# ADDENDUM 1

PROJECT NAME: **MARTIN LUTHER KING PARK**

DATE: 09/21/2016

PROJECT NO.: **40-00374**

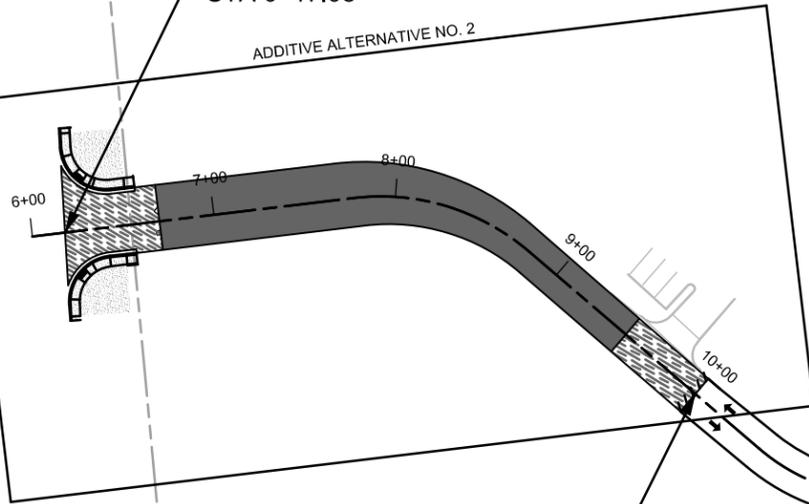
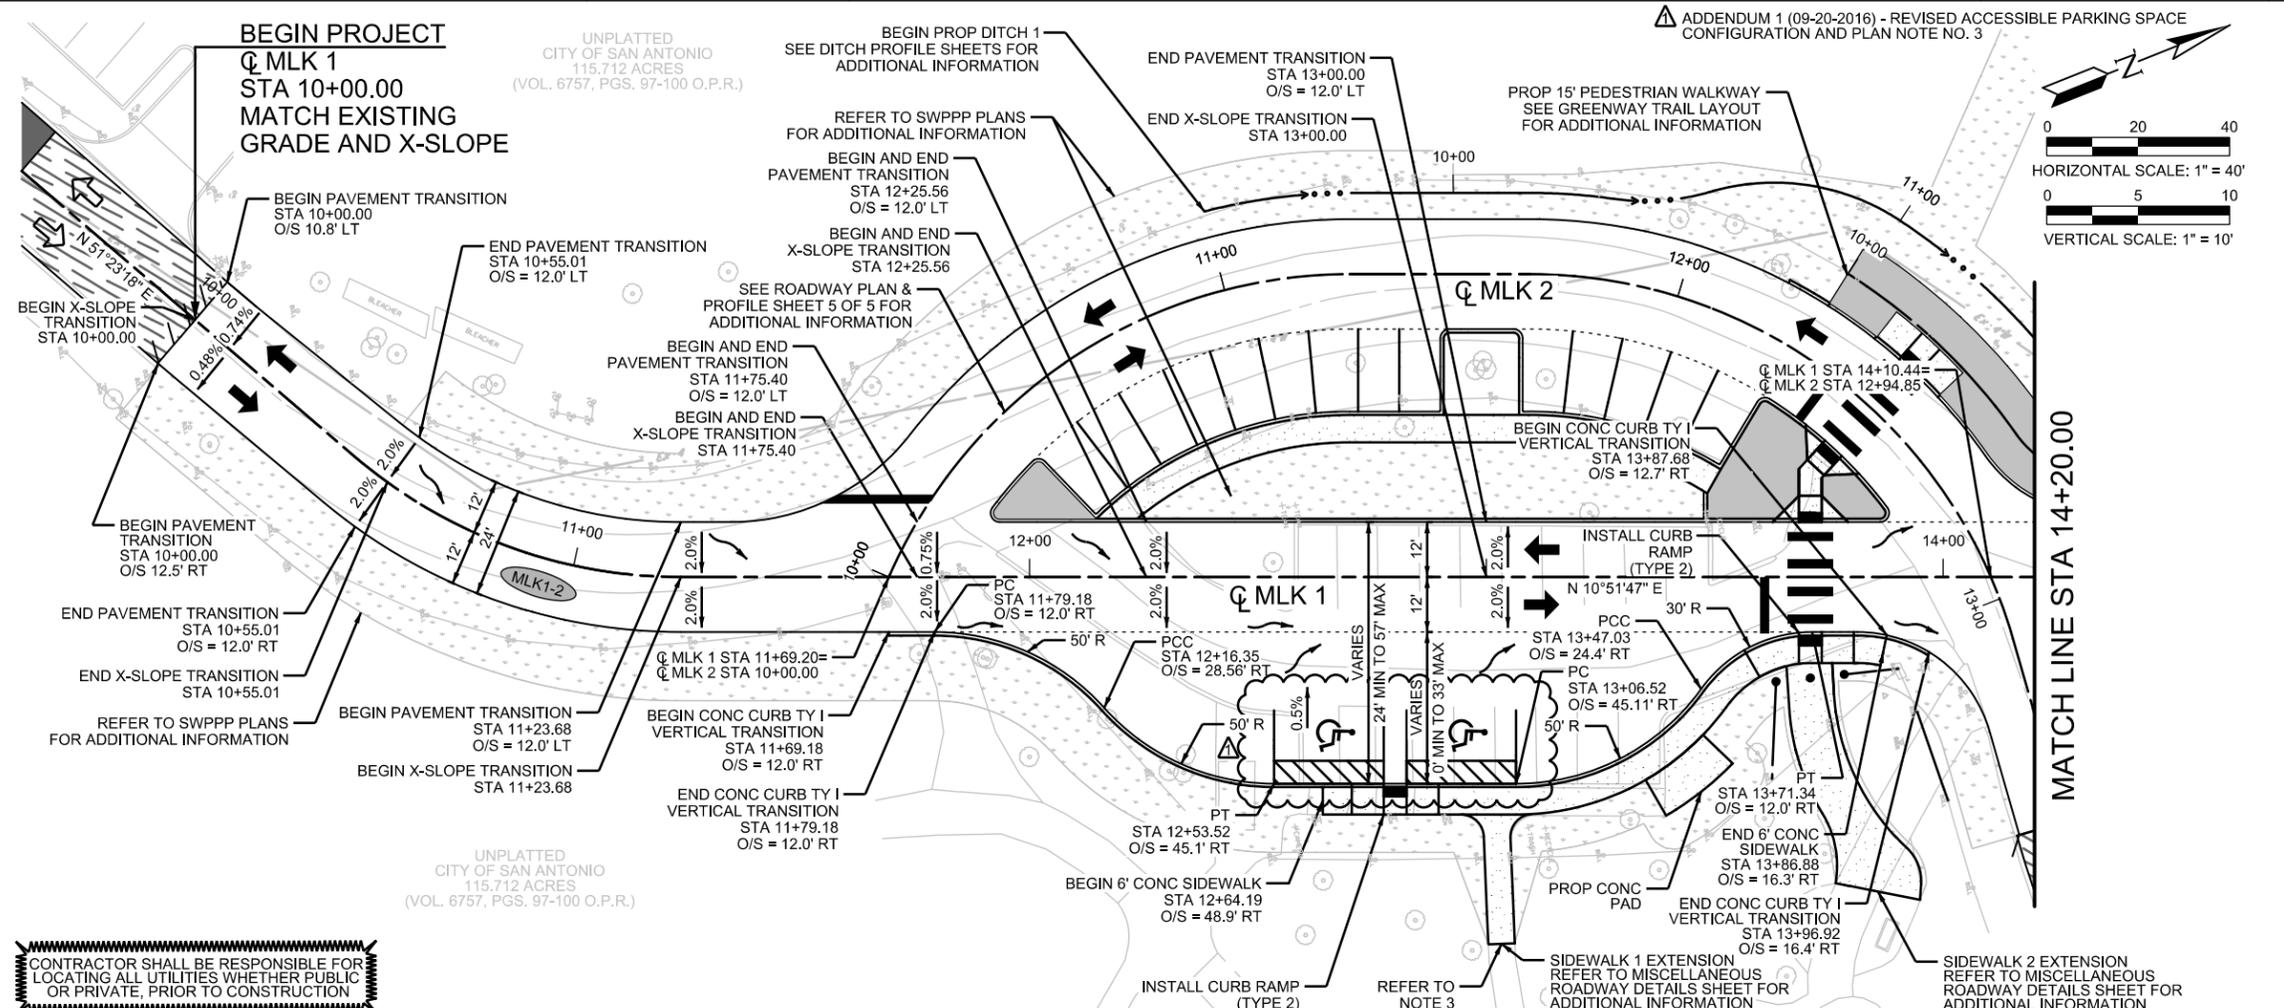
- n. Sheet 43A “SHEET INDEX LAYOUT” Sheet 2 of 2
  - i. Added Sheet 43A “SHEET INDEX LAYOUT” Sheet 2 of 2
- o. Sheet 44 “ROADWAY PLAN & PROFILE MLK 1 STA 10+00.00 TO 14+20.00”

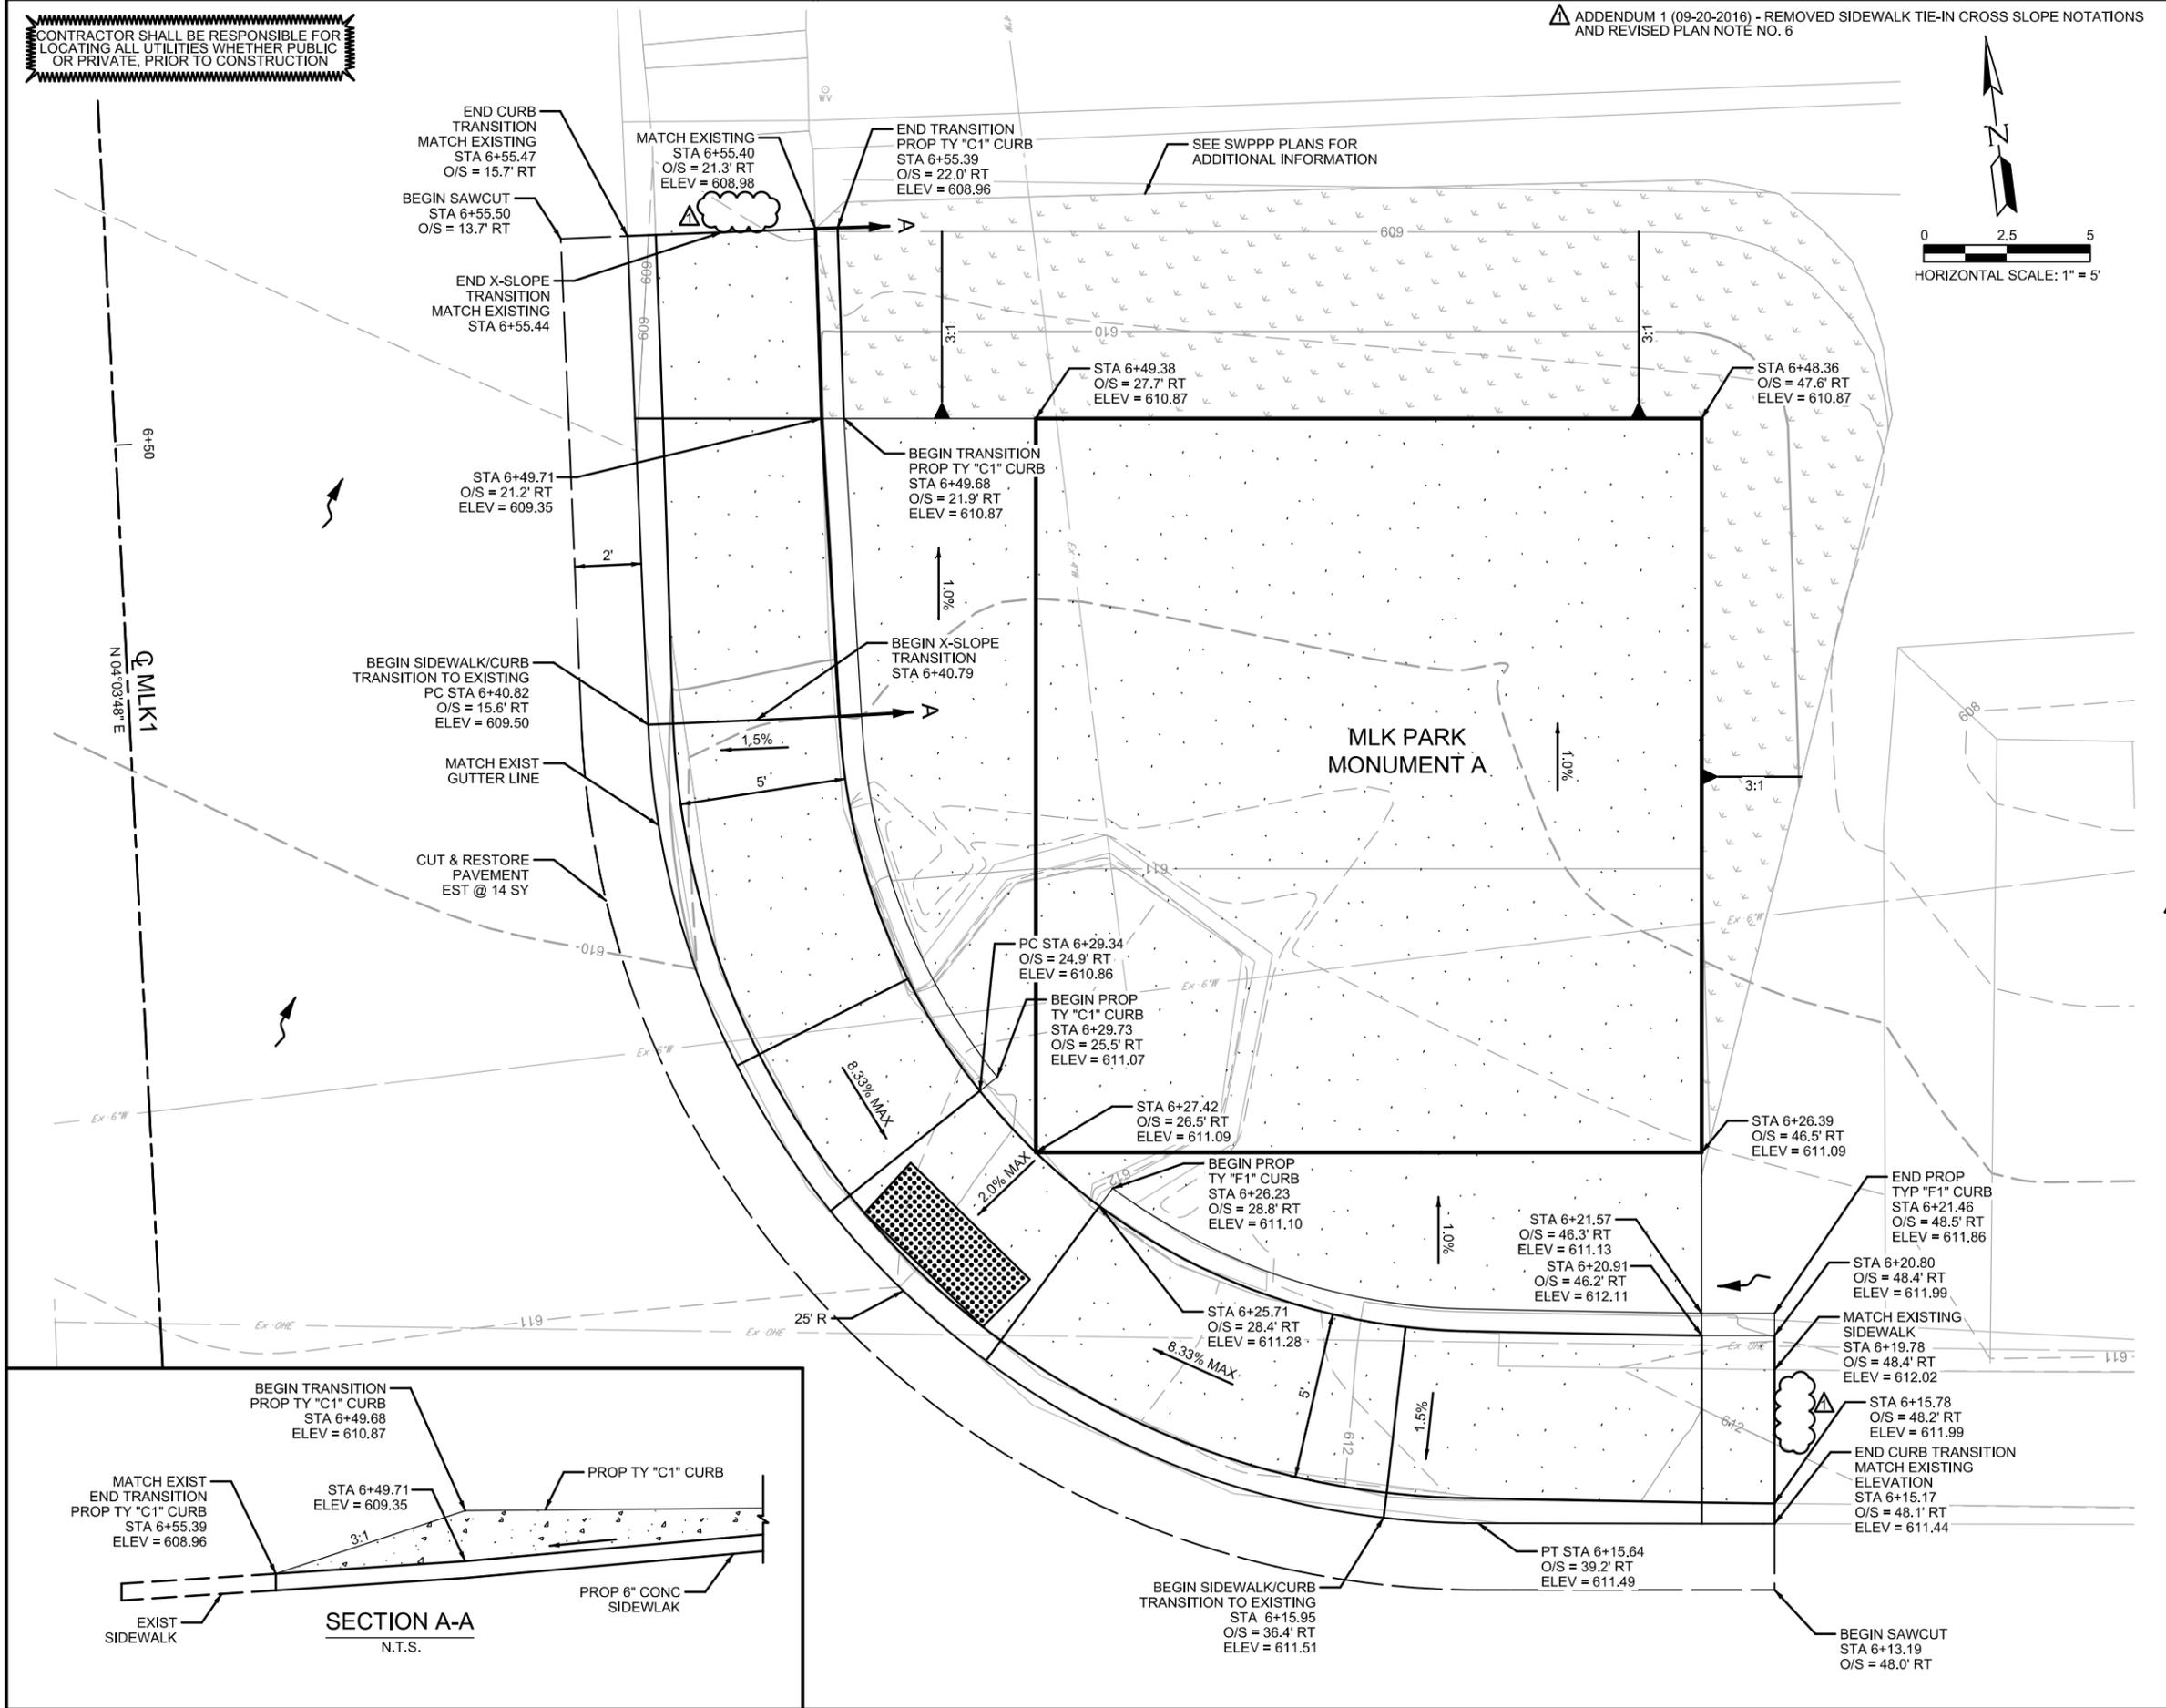
- i. Revised accessible parking spaces configuration
  - ii. Revised plan note No. 3
- p. Sheet 51 “SITE LAYOUT (MONUMENT A)”
  - i. Removed sidewalk tie-in cross slope notations

- ii. Revised plan note No. 6
- q. Sheet 52 “SITE LAYOUT (MONUMENT C)”
  - i. Revised sheet title
  - ii. Revised Monument identification from “B” to “C”

ADDENDUM 1 (09-20-2016) - REMOVED SIDEWALK TIE-IN CROSS SLOPE NOTATIONS AND REVISED PLAN NOTE NO. 6

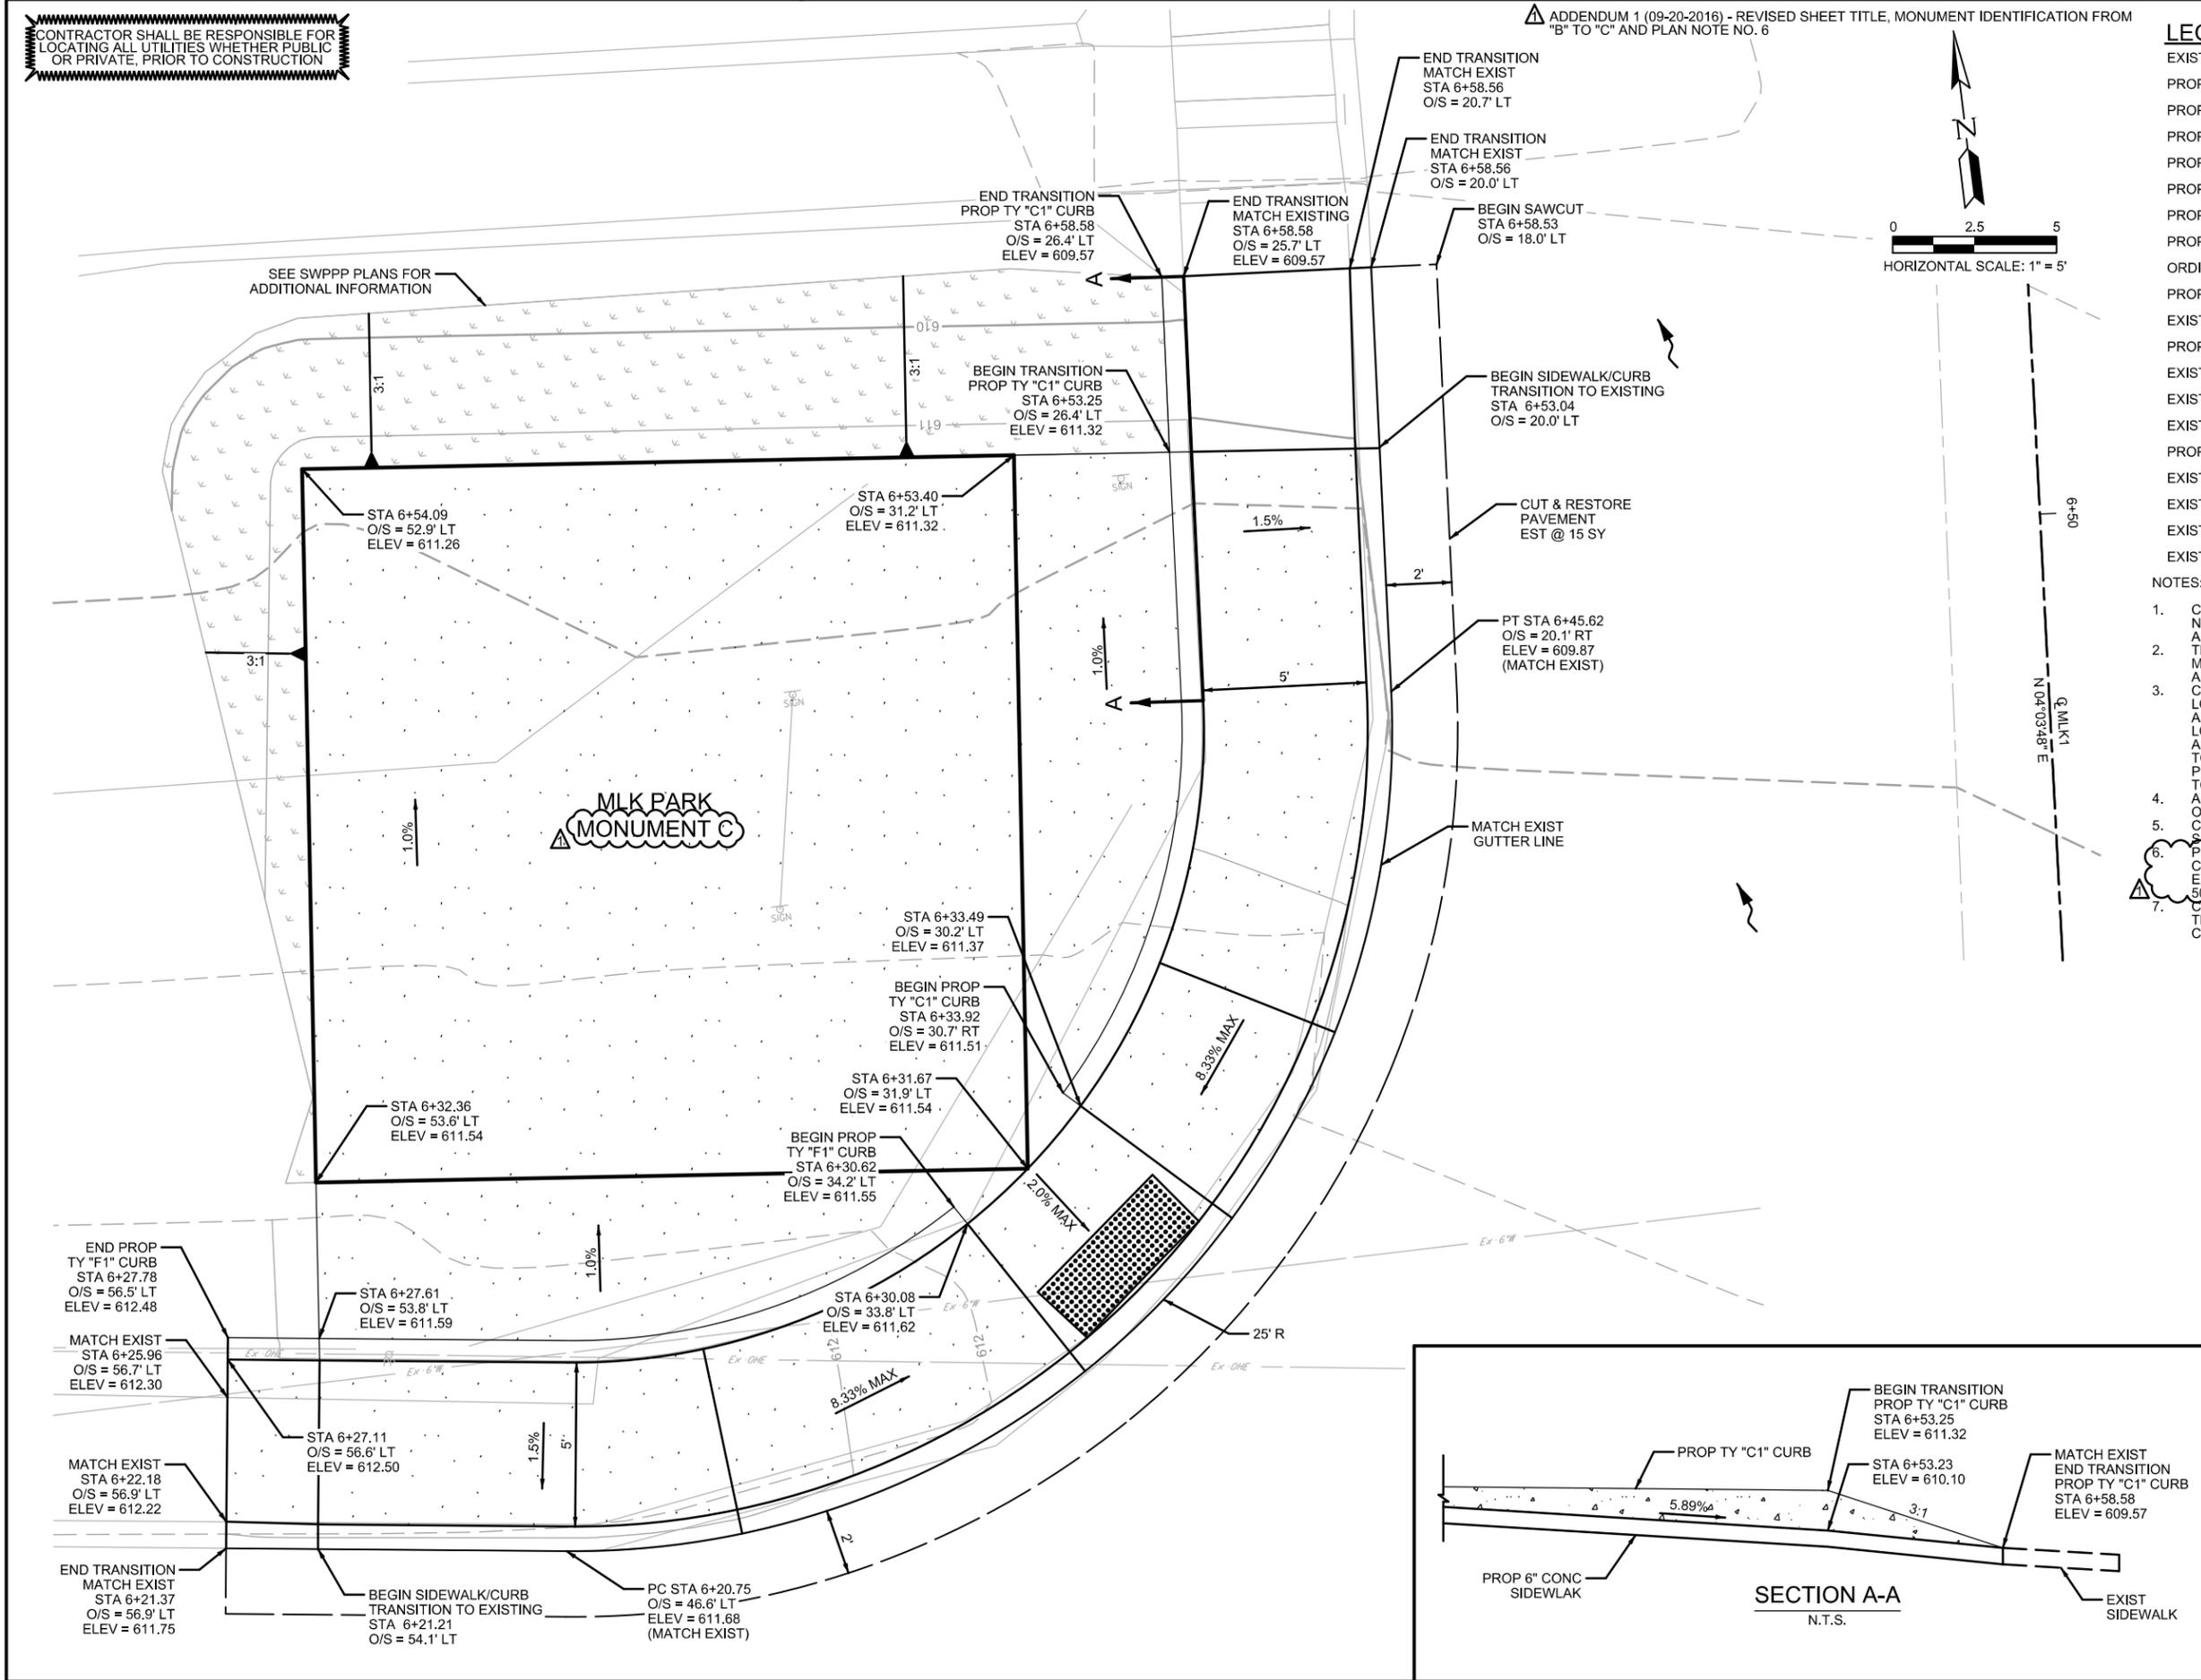
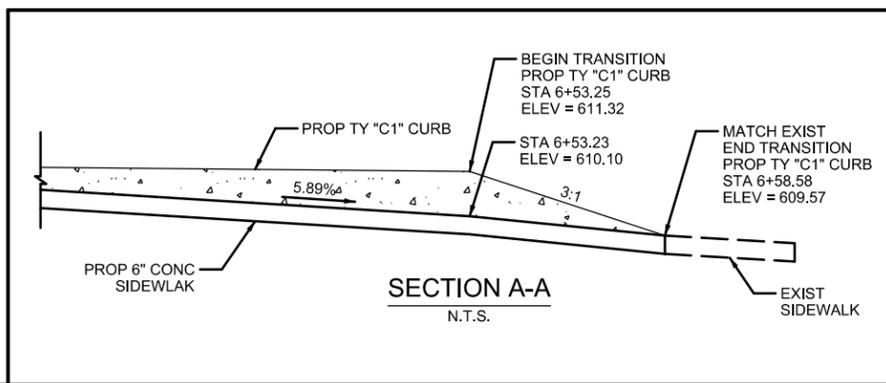
- iii. Revised plan note No. 6
- r. Sheet 52A “ADDITIVE ALTERNATIVE NO. 2 – MLK 1 STA 6+17.98 TO 10+00.00”
  - i. Added Sheet 52A “ADDITIVE ALTERNATIVE NO. 2 – MLK 1 STA 6+17.98 TO 10+00.00”
